Technical Service Bulletin

Mazda North American Operations
Irvine, CA 92618-2922

Subject: COOLANT LEAKS AT CYLINDER HEAD	Bulletin No.: 01-010/24
	Last Issued : 11/27/2024

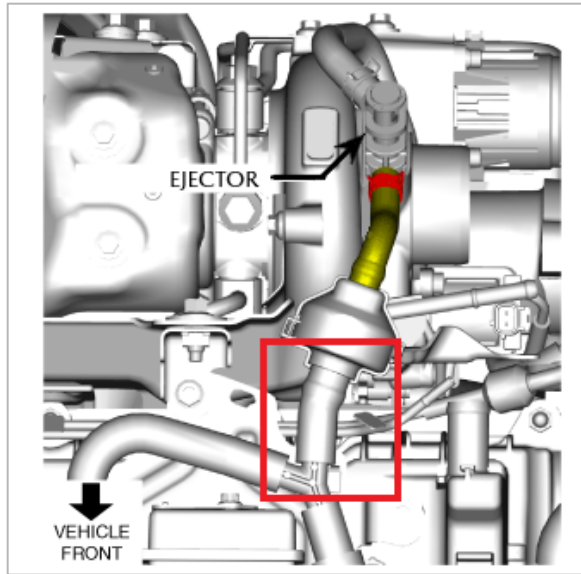
Some vehicles may have coolant leaks at the cylinder head around the exhaust manifold (as shown below). There may be cracks at the stud bolt hole (1) or at the outside of the exhaust manifold flange (2) on the cylinder head.

- Expansion characteristics of the exhaust manifold during usage causing unexpected force to certain areas of the cylinder head.
- Residual stress generated during production in the cylinder head material may be greater than expected. The external force from the exhaust system when driving over bumps may cause unexpected force to certain areas of the cylinder head.

To eliminate this concern, the design of the exhaust manifold gasket and the cylinder head has been modified to reduce the force on the cylinder head.
